## **Amendment to the Drawings**

## **REMARKS/ARGUMENTS**

Appl. No. 10/628,097 Amdt. Dated May 2, 2005 Reply to Office Action of August 30, 2004 Annotated Sheet Showing Changes

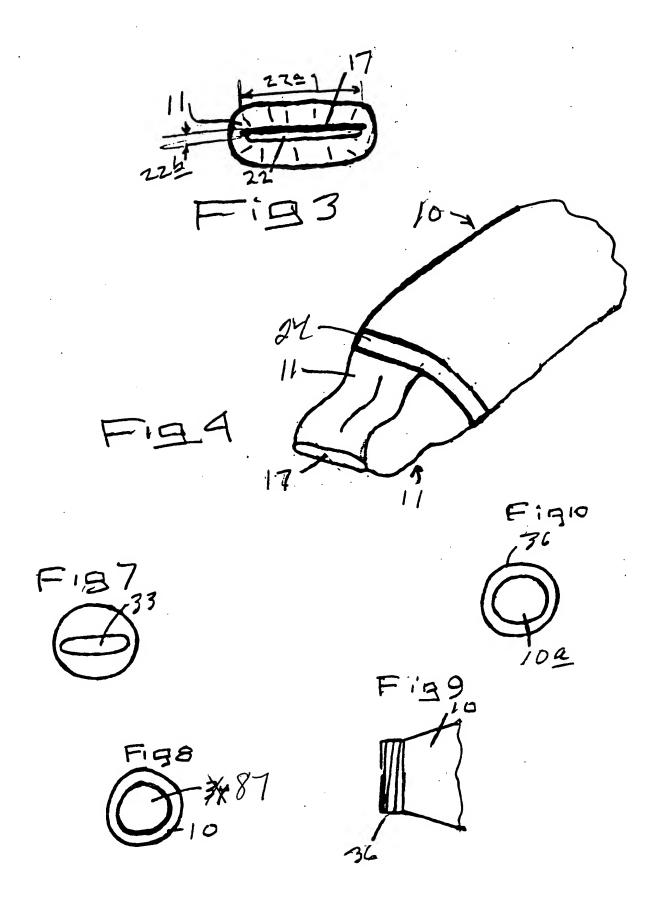
The attached replacement sheet of drawings includes changes to FIGS. 1, 2, 5, 6, 8, 15, 18, 19, 19a and 20, as indicated in the replacement sheet of drawings attached hereto.

In response to the objections to the drawings, the Applicant and amended the specification and submits wherewith proposed replacements sheets wherein Figures 1, 2, 5, 6, 8, 15, 18, 19, 19a, and 20 wherein proposed corrections have been made. In particular: Figures 1 and 2 have been modified to include reference number 21; Figure 5 has been modified to remove reference number 32a; Figure 6 has been modified to correct the position of the lead line for reference number 189; Figure 8 has been modified to replace reference number "34" with "87"; Figure 15 has been modified to make reference number "61a" clear; Figure 18 has been modified to show how the views in the figure interrelate; Figures 19 and 19a have been modified to replace reference number 110a' with 110b; and Figure 19 has been modified to replace the incorrect use of reference number "112a" with "102"; Figure 20 has been modified to replace the incorrect use of reference number "17" with "17a". The corrections do not add any new matter and approval of the proposed changes is respectfully requested.
